5,000 psi Blind Shear Ram Bolting

Safety Notice

VIEWED: 2016/05/12 17:18:09
DOCUMENT: SN16-001 | NC

Figure 1. Bolt identification

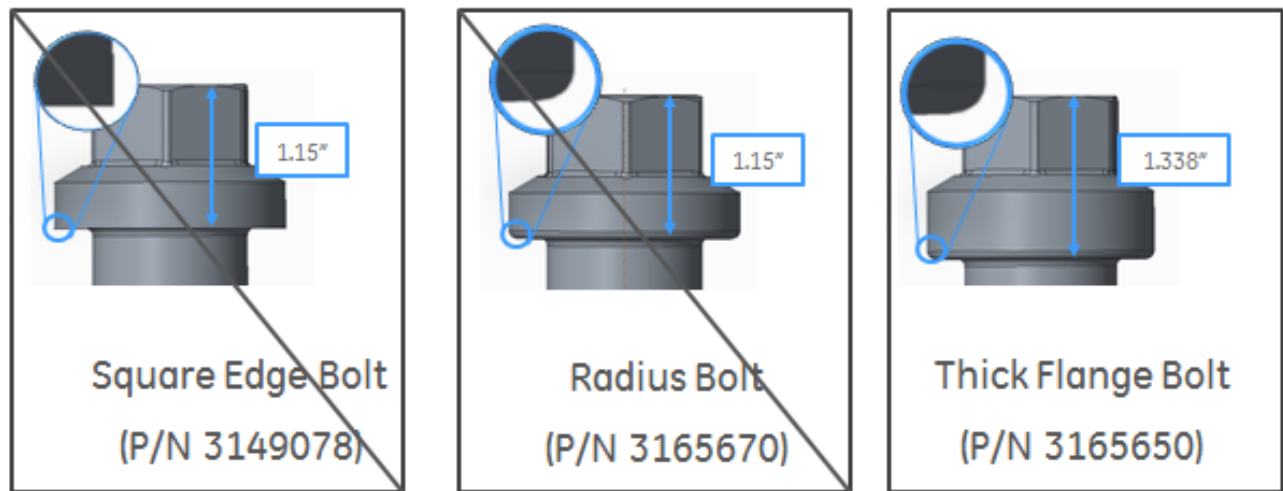
- Discontinue the use of P/N 3149078 and P/N 3165670. Refer to Figure 1.
- Install new upper front attachment bolts P/N 3165650 (thicker flange).

Figure 2. For reference: 5K BSR Assembly

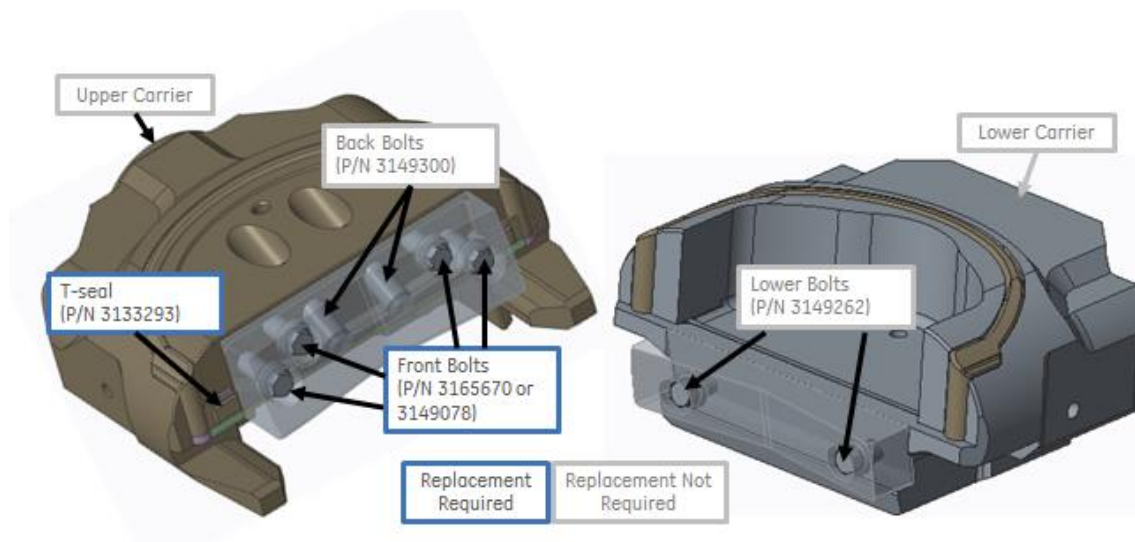
The actions in this Safety Notice are considered complete when the upper front bolting and the T-seal are replaced and installed per X-1007757 Rev. F or later and re-tested as necessary. Refer to Figure 2 and Table 1.
